## **LIMPSCOMBE LANDING SUBDIVISION**

The plat illustrates the proposed 22.1± acre, 8-lot subdivision which is located on the Northeast corner of Lipscomb Landing and River Oaks Drive extending to the South side of Wragg Swamp Canal, and is in Council District 4. The applicant states that the subdivision is served by both public water and sanitary sewer. The purpose of this application is to create eight legal lots of record from nine metes-and-bounds parcels. The site was the subject of Subdivision and Planned Unit Development applications at the Planning Commission's September 21, 1995 meeting, at which the applicant obtained approval for a 5-lot subdivision with a 1,000'± private road.

APPLICATION NUMBER 9 DATE January 7, 2016

# DETAIL SITE PLAN

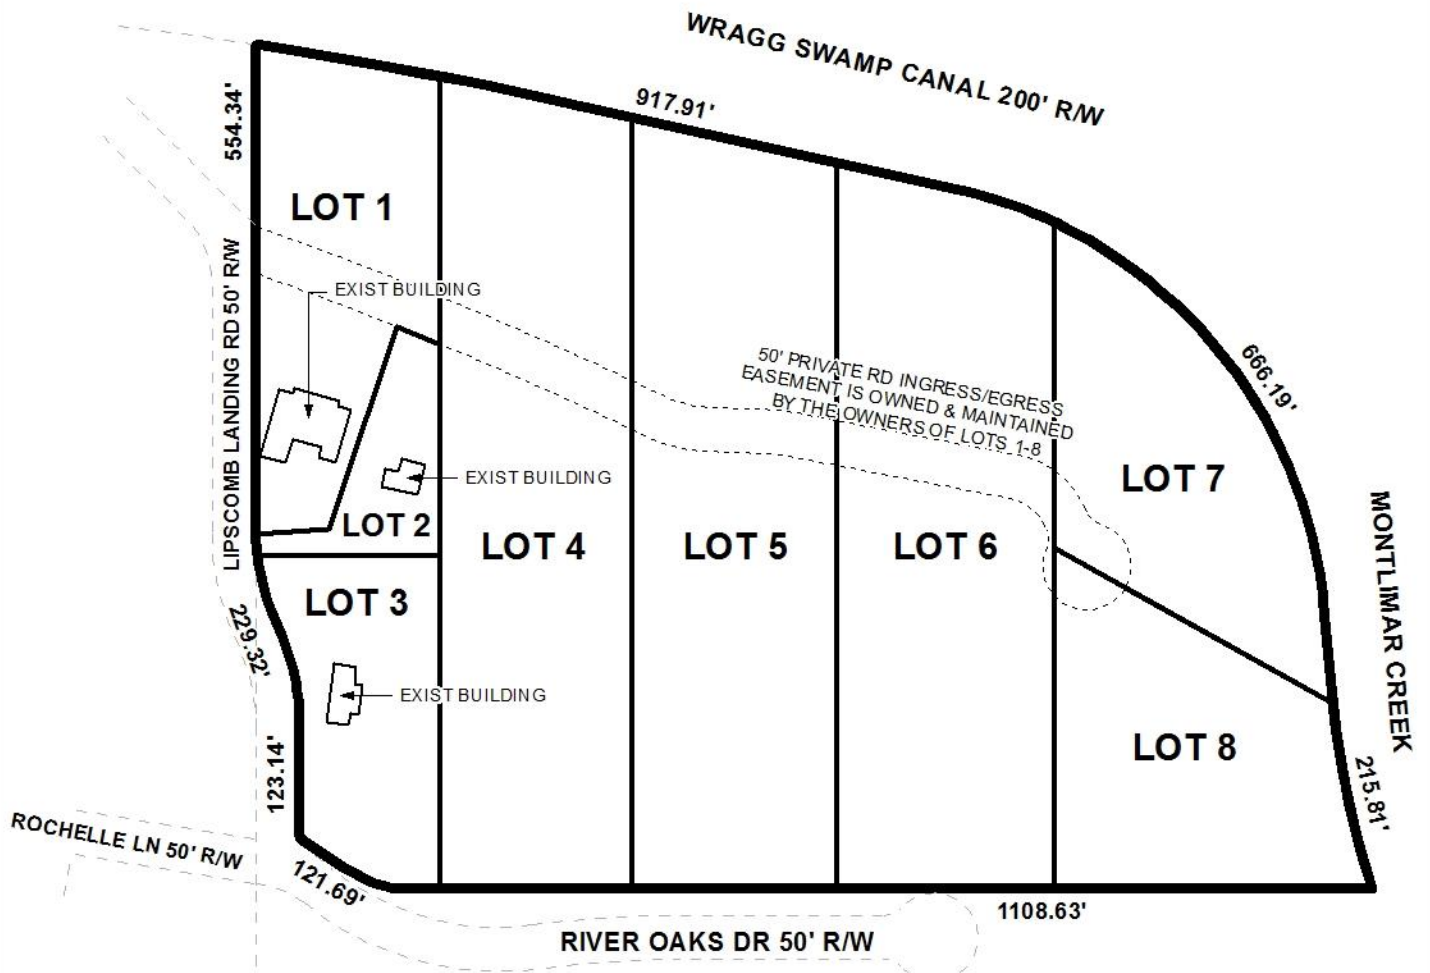
The preliminary plat indicates a proposed 50' wide private road that terminates in a 50' radius cul-de-sac and bisects proposed Lots 1, 4, 5, 6, 7, and 8. It should be noted that because this is a proposed private road within the city limits, that a Planned Unit Development application should also be submitted to the Planning Commission. Section V.B.6. of the Subdivision Regulations states that closed-end streets shall not exceed 600 feet, and the preliminary plat illustrates the proposed private road to be 1,000'± long. Because the site received prior approval from the Planning Commission in 1995 for an almost identical private road, a waiver of Section V.B.6. of the Subdivision Regulations may be appropriate, subject to Fire Department approval. It should be noted that Section V.B.14. of the Subdivision Regulations require a turnaround diameter of 120 feet, therefore, if approved, the proposed cul-de-sac should be revised to meet this requirement.

The 25-foot minimum building setback line, required in Section V.D.9. of the Subdivision Regulations, is not shown on the preliminary plat, and should be illustrated along the proposed private road. The setback should be illustrated as a 30-foot setback along Lipscomb Landing on the Final Plat, if approved, to accommodate future right-of-way improvements.

The proposed lot sizes are not provided in square feet or acres, but appear to meet the minimum required lot size of 7,200 square feet in Section V.D.2. of the Subdivision Regulations. If approved, the Final Plat should be revised to include the lot sizes in square feet and acres.

As a means of access management, Lots 1 and 3 should each be limited to one curb-cut to Lipscombe Landing, with all other lots limited to access only to the proposed internal private street with driveway number, size, location and design to be approved by Traffic Engineering and conform to AASHTO standards.

- 1) submittal of a Planned Unit Development application, or revision of the preliminary plat to depict a public road; and
- 2) revision of the plat to illustrate minimum building setbacks and a 120' diameter cul-de-sac.
